**ONONDAGA LAKE BOTTOM  
PHASE I – SEDIMENT CONSOLIDATION  
AREA CONSTRUCTION  
CONSTRUCTION QUALITY ASSURANCE (COA)  
FINAL REPORT – Volume I  
ONONDAGA COUNTY  
TOWN OF CAMILLUS, NEW YORK**

Project Number GJ4706B

May 2012 (Revision 0)  
August 2012 (Revision 3)

Geosyntec <sup>®</sup>		KENNESAW, GA	
consultants			
DATE:	Aug-11	SCALE:	AS SHOWN
PROJECT NO.	GJ4706.08	FILE NO.	—
DOCUMENT NO.	—	FIGURE NO.	1

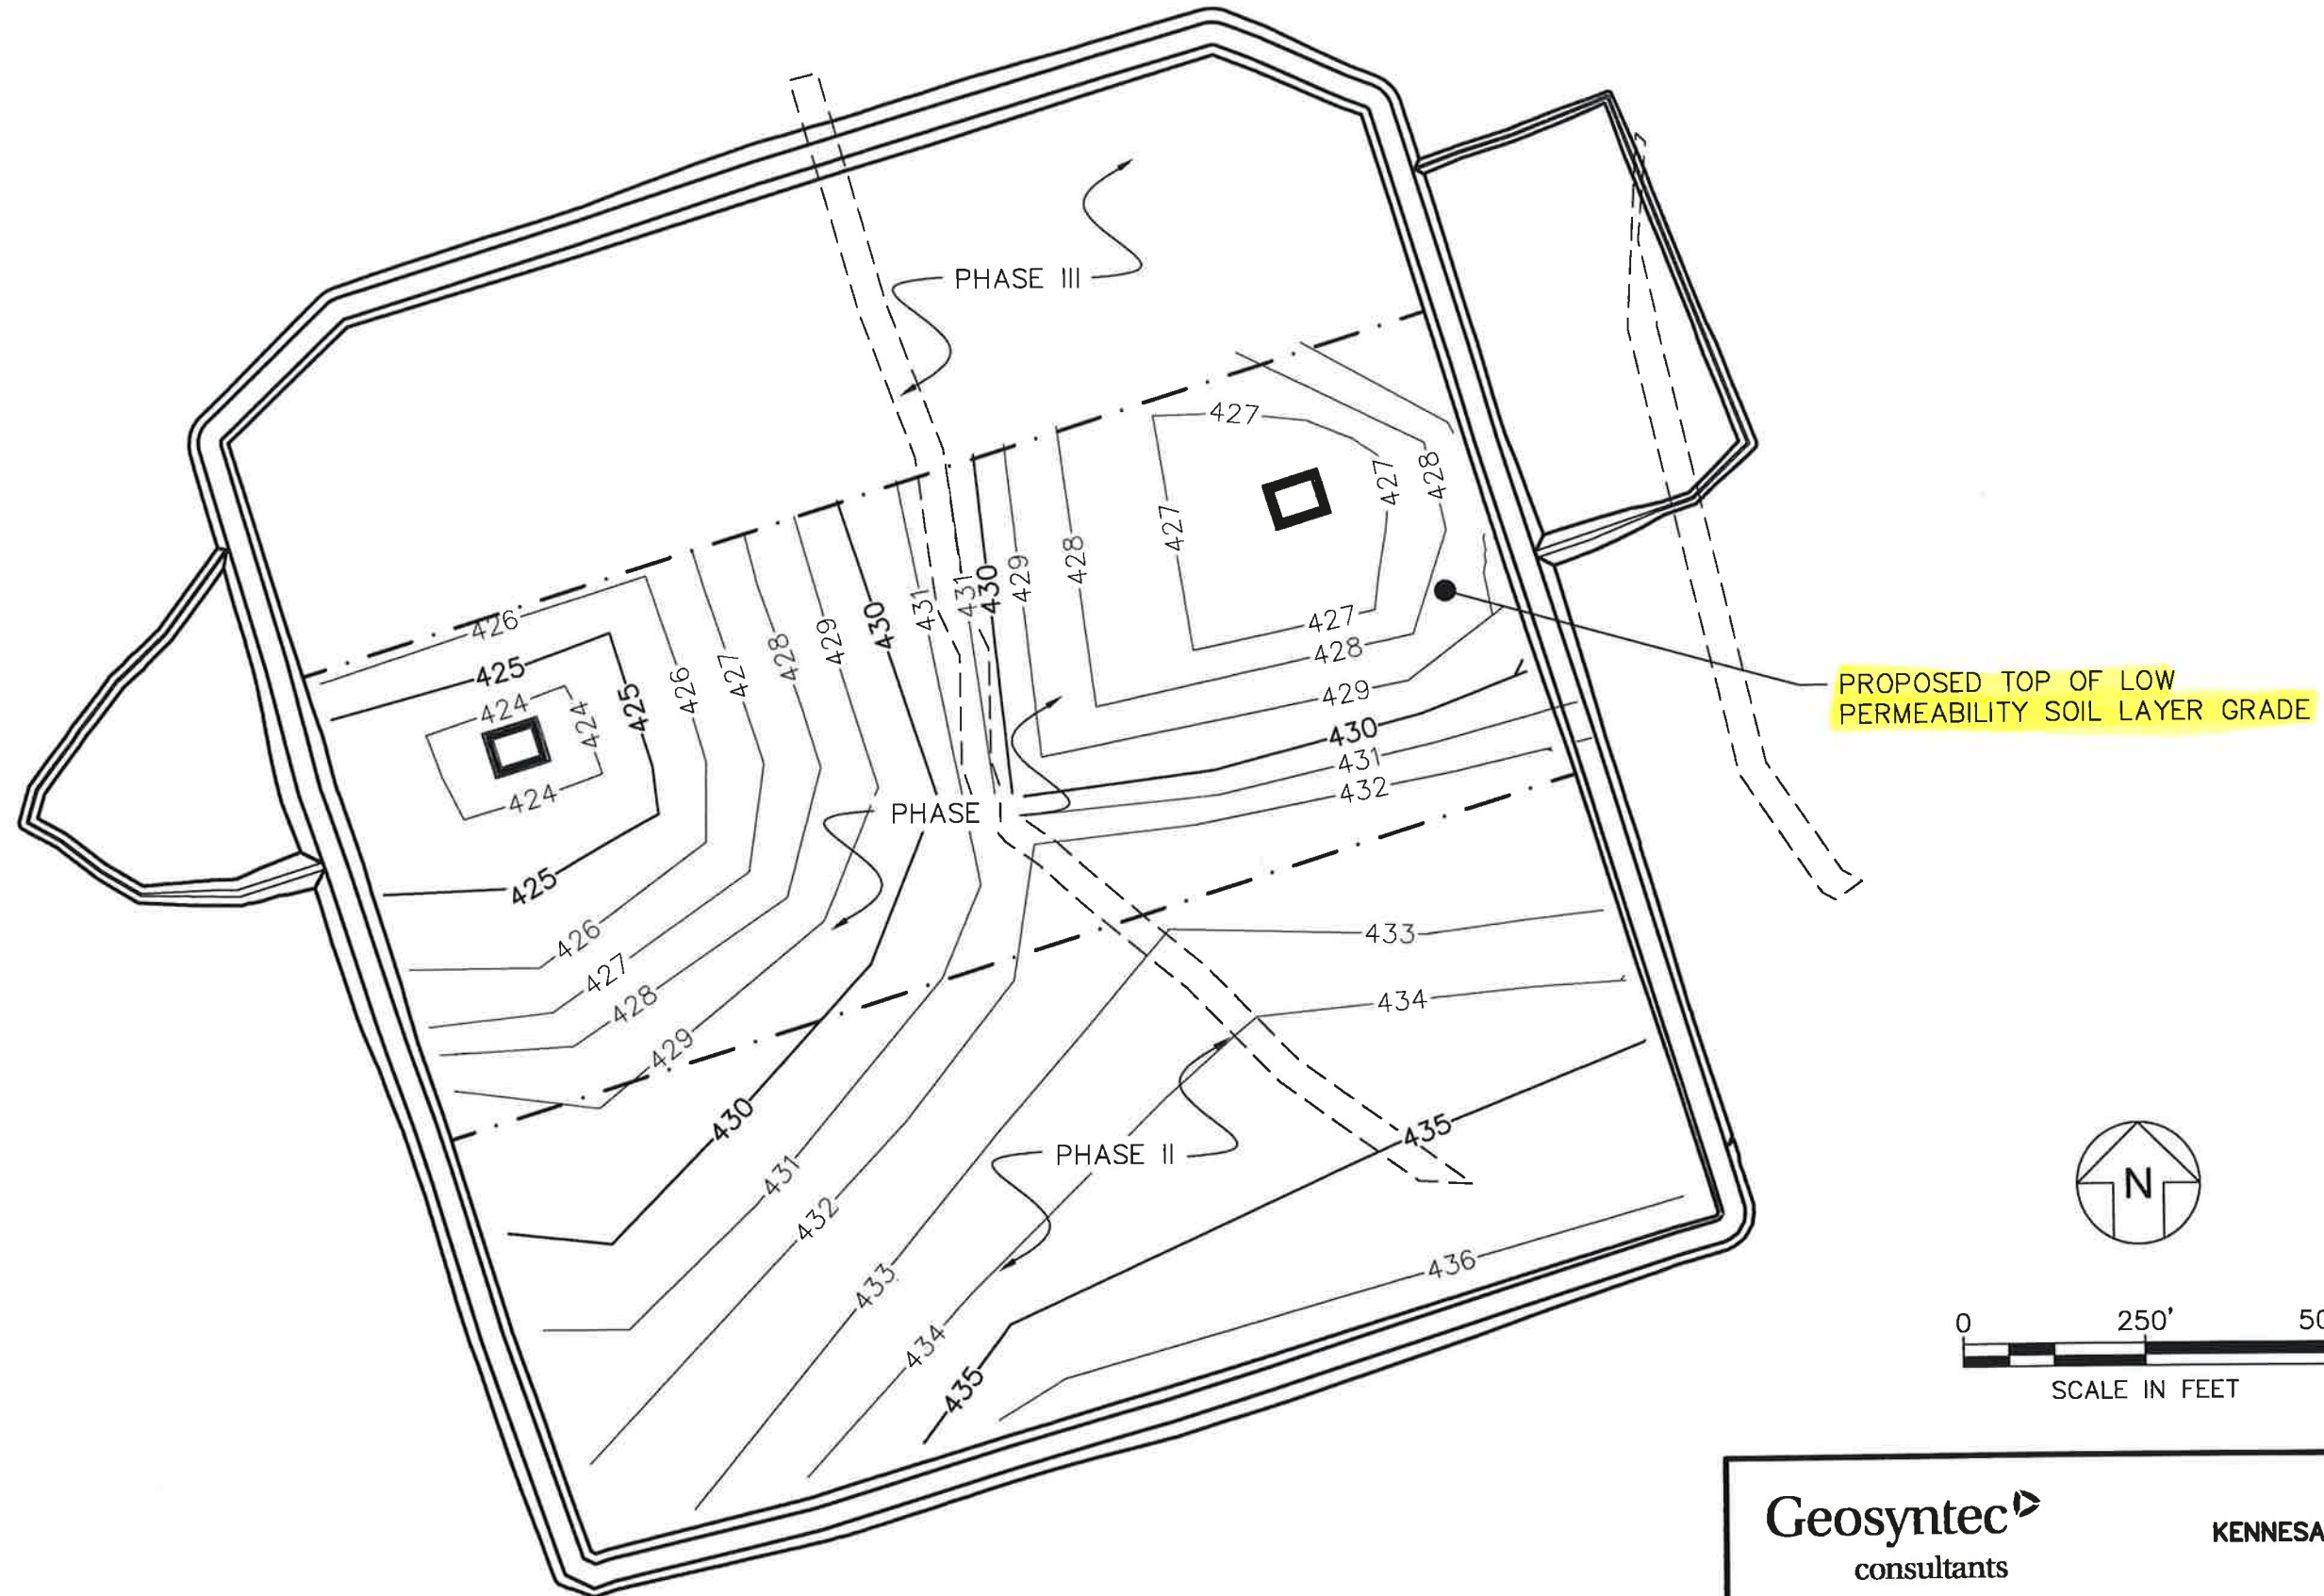
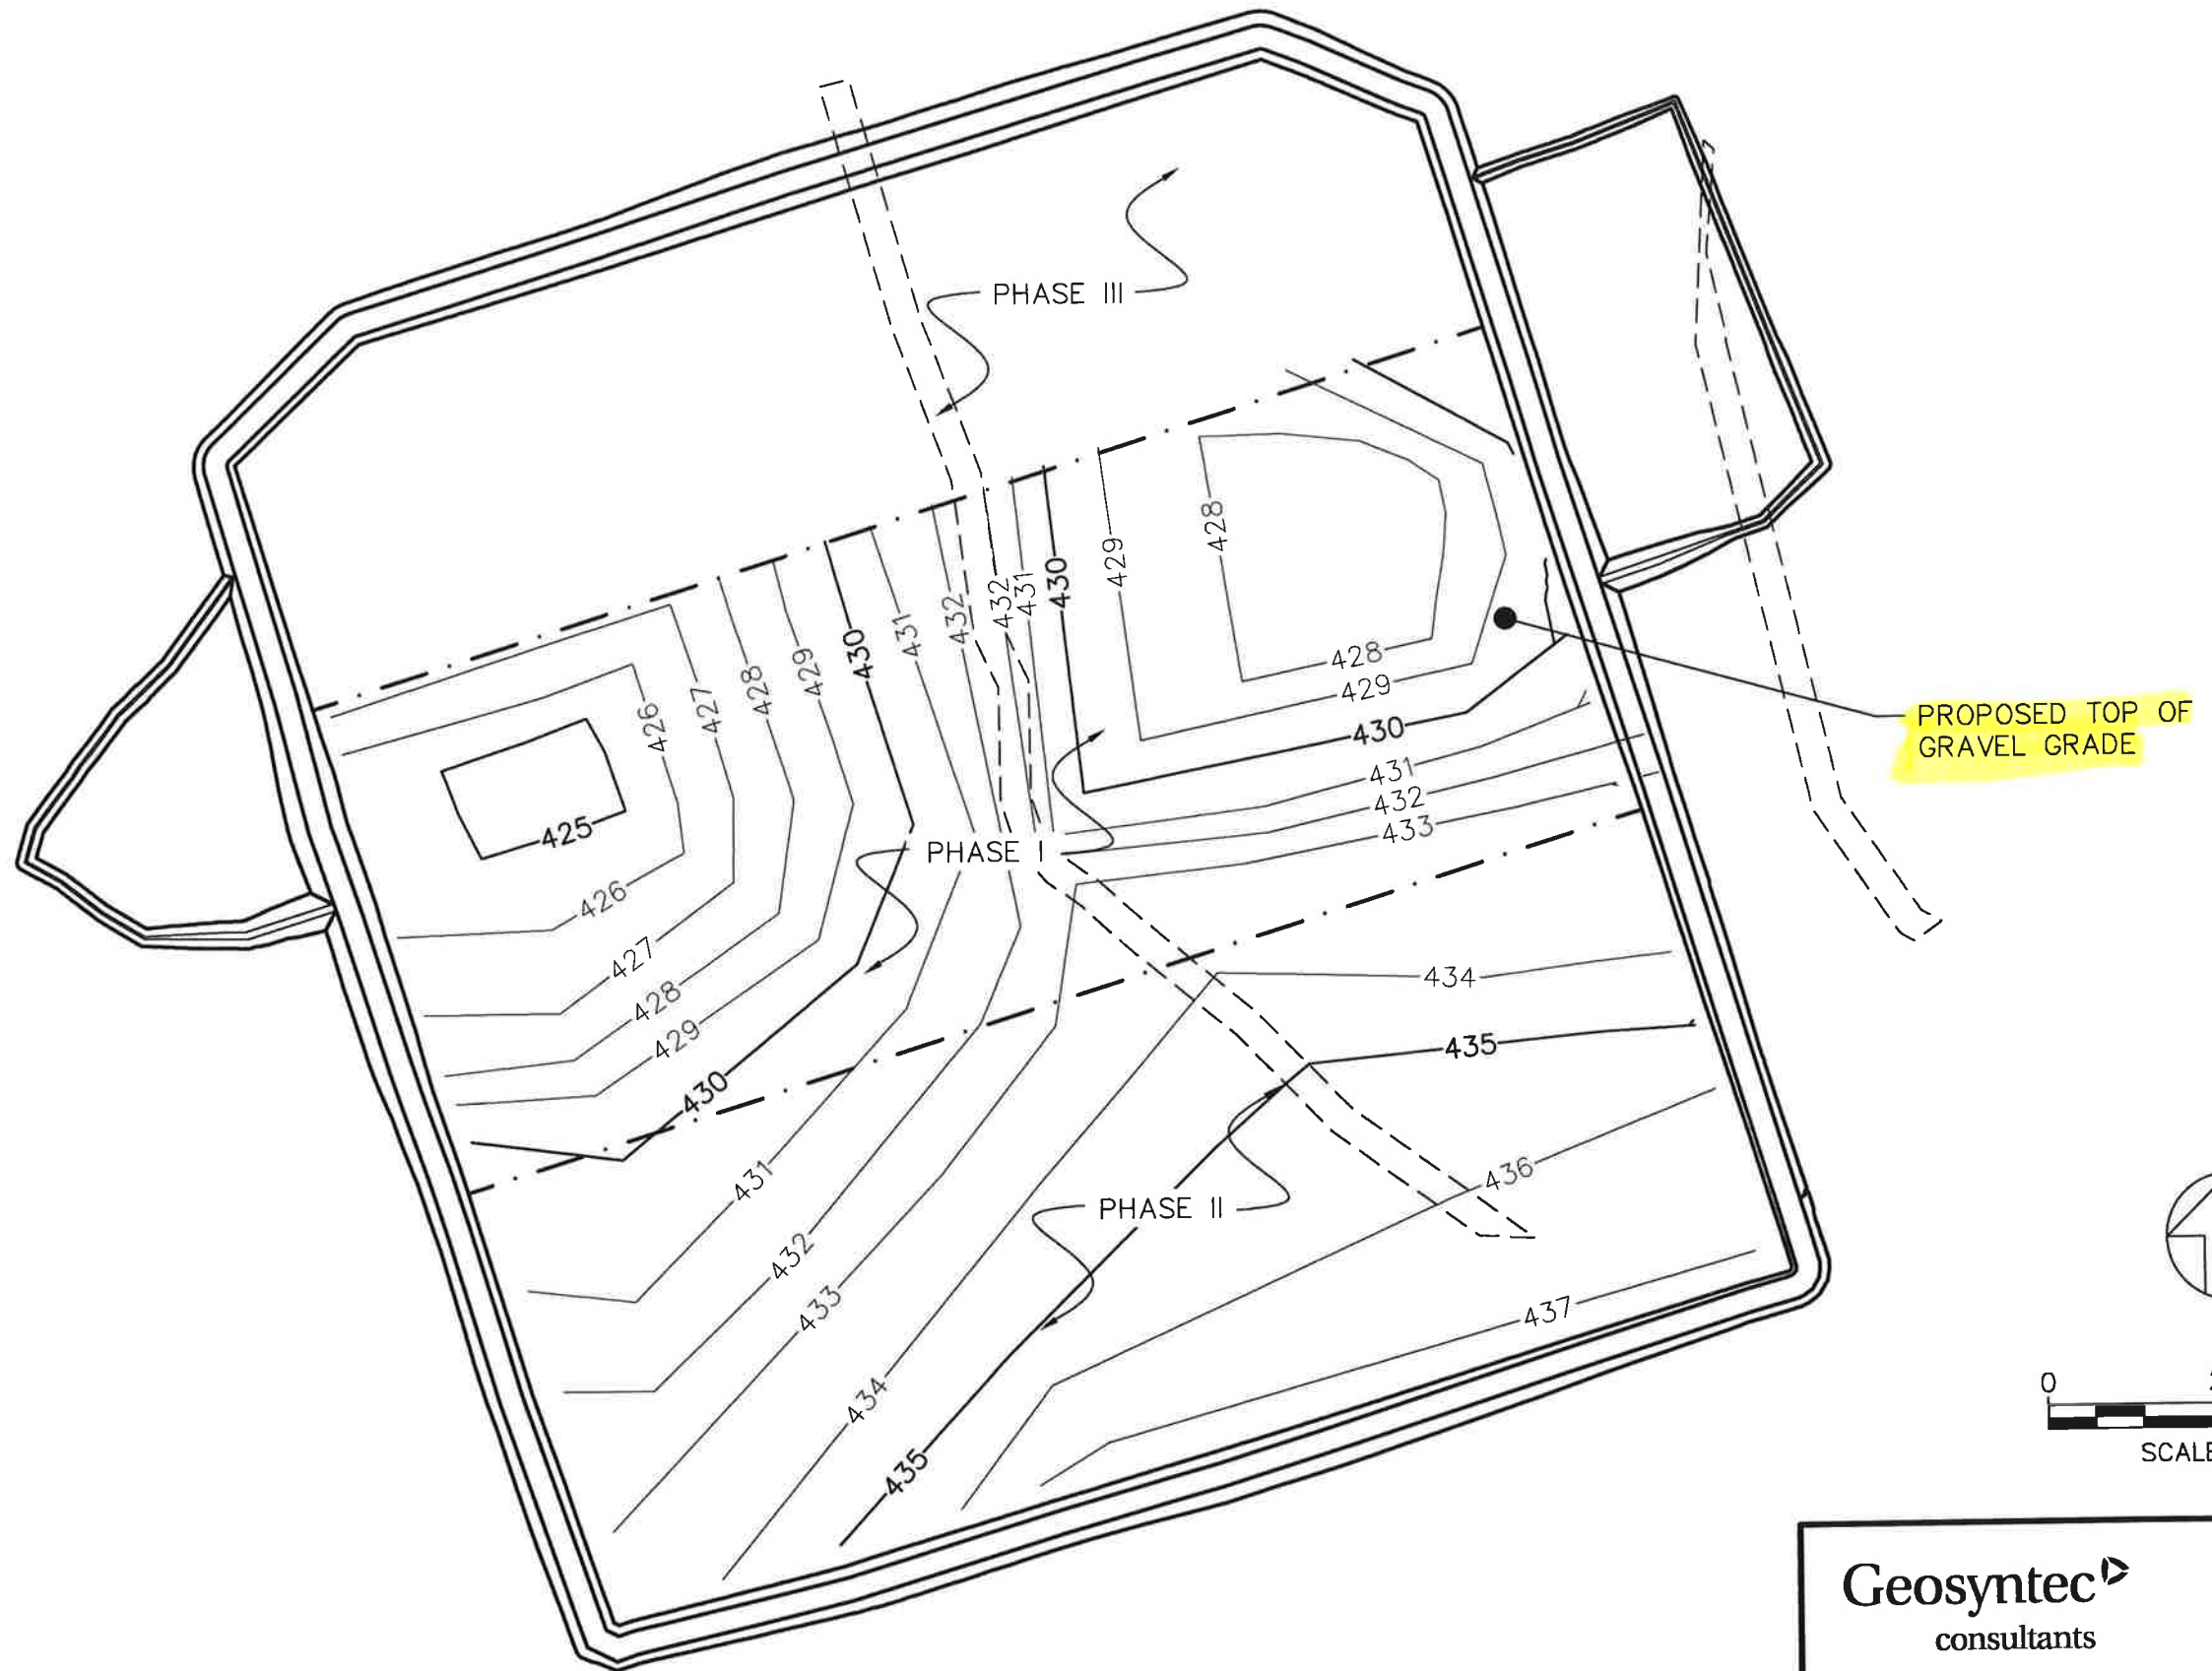
Drawing C-006 shows the elevations for the top of the berms around the SCA. Drawing C-009 shows the height of the temporary berm to be 5.7 feet. The east and west berms of the SCA are being built 0.5 feet lower than the design to account for the land-based topography data (as discussed in Field Change Form #3). This RFI is to ask what elevations are required for the top of the east and west berms and the top of the temporary berm to provide the necessary containment during the period when only Phase I and II are in operation.

Original Analysis - Before survey bust, minimum berm elevation of 434 ft msl

- 1.) It is noted that the minimum height of the berm is considered to be 2 ft above the Top of Gravel. This results in a minimum berm elevation of 434 ft msl in Phase I and 436 ft msl in Phase II.
- 2.) The minimum freeboard requirement is considered to be 0.5 ft (6").
